RFP Title: Site Improvements at Peace & Plenty Park

Addendum #: 3

Addendum # 3

Site Improvements at Peace & Plenty Park

29 ADD/ALT #3 - KOMPAN JUNIOR SPICA SPINNER
NTS

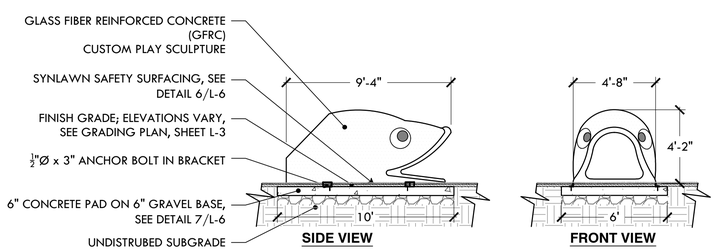
1. Addendum Cover Sheet (1 Page)
    a. Due to the discontinuation of the production and sale of the Whimsy Riders (Zebra Springers) by Landscape Structures Inc. (LSI), Add Alt #3 has been changed to F&I (Furnish and Install) Kompan Junior Spica Spinners
    b. To address the request for additional information on the custom play sculpture, including potential dimensions, weight and installation process, this addendum includes manufacturer's proposed installation instructions draft
2. Construction Plans (3 Pages)
    a. Sheet L-4 Materials Plan
    b. Sheet L-5 Layout Plan
    c. Sheet L-9, Detail 29 – Kompan Junior Spica Spinner footing detail
3. Cre8Play Custom Play Sculpture installation instructions (5 pages)
4. RFP Bid Package Specifications (5 Pages)
5. Technical Specification Section 116800 Play Field Equipment and Structures (5 Pages)
6. Pre-bid Sign-in Sheet (1 Page)

NOTES:
1. DETAIL SHOWN FOR ESTIMATION PURPOSES ONLY
2. CONTRACTOR TO REFER TO MANUFACTURER'S INSTALLATION DRAWINGS AND SPECIFICATIONS
